BLUE BIRD

R10RW

Incorrect Power Cable Lug Orientation

Models Affected: 2004 through 2009 Vision

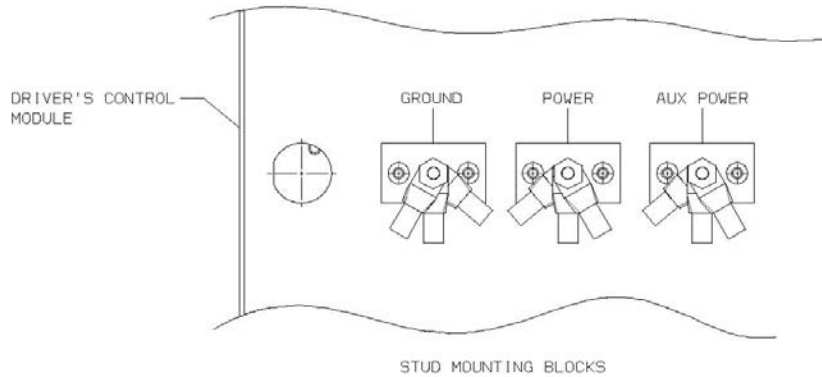
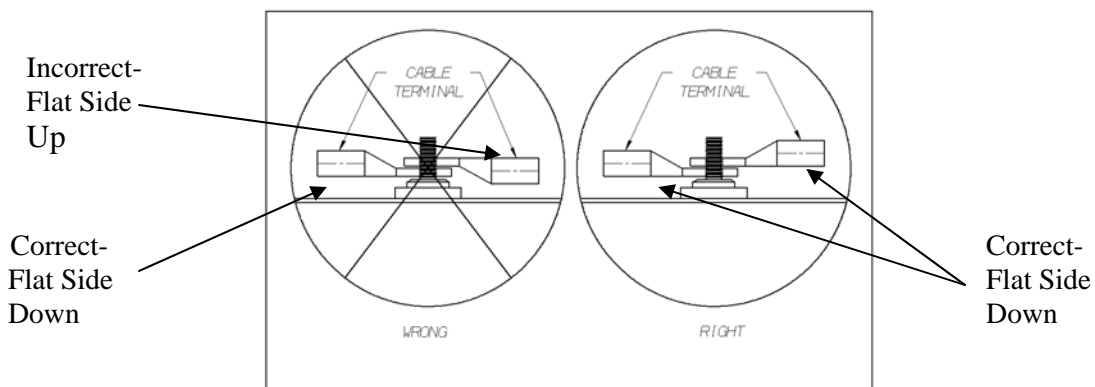
1. Park the vehicle on a level surface, apply parking brake, turn engine off, remove ignition key and chock wheels.
2. Disconnect batteries. *Always remove negative cables first.*
3. Open engine hood and locate the Chassis Power Stud(s) on the driver's side of the **Driver's Control Module (DCM)**. Depending on the type of engine installed and options on the vehicle (air conditioning and/or lift), there could be one or two power studs next to the Ground Stud. See the following diagrams.

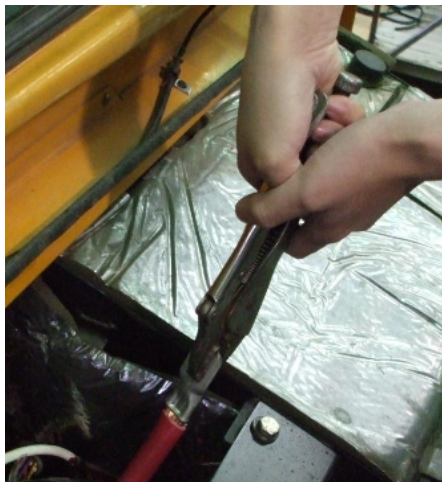
4. Inspect the electrical cable connections at the Power Stud and Aux Power Stud, if installed. See the diagram below to determine if the cables were installed correctly. ALL terminal lugs on each power stud should be oriented such that the barrel of the lug is further away from the mounting surface of the isolated stud. The flat side of terminal end (lug) must be down.

5. If the cables were installed incorrectly, remove the nut securing the cables. Then remove the cables and reinstall correctly per the diagram above. Make sure the terminal lugs are fanned out on the stud as opposed to directly on top of each other. Vice-grip pliers are recommended when turning incorrectly installed cable terminal lug to the correct orientation of flat side down.

Caution: Do not grasp cable on insulation

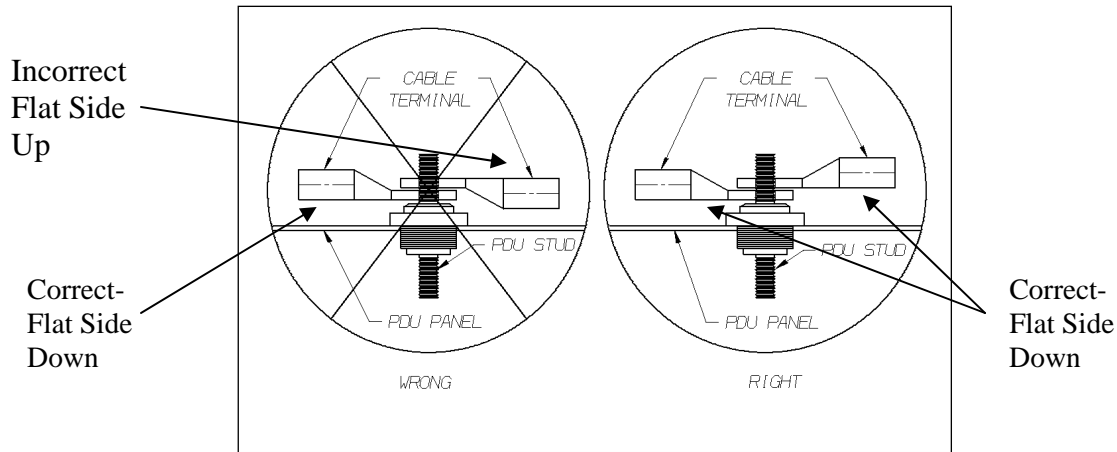
10. Remove the two red protective covers and inspect the electrical cable connections at the Power Studs.

ALL terminal lugs on each power stud should be oriented such that the barrel of the lug is further away from the mounting surface of the isolated stud. The flat side must be down.

11. Remove the nut securing the cables. Then remove the incorrectly installed cables and reinstall correctly with flat side down. Make sure the terminal lugs are fanned out on the stud as oppose to directly on top of each other.
12. If needed, use vise grips to rotate cable so lug fits with flat side down. See photo on page 2.
13. Secure the cables with the nut and torque to 12 to 15 ft-lbs.
14. Apply corrosion resistant coating (glyptal) as required to prevent corrosion.
15. Reinstall the red protective covers.
16. While having access to this area, inspect ALL power cables for any evidence of contact with the rear of the engine, chaffing, or other damage. **Ensure clearance between power cables and any part of the engine is more than ½ inch.**
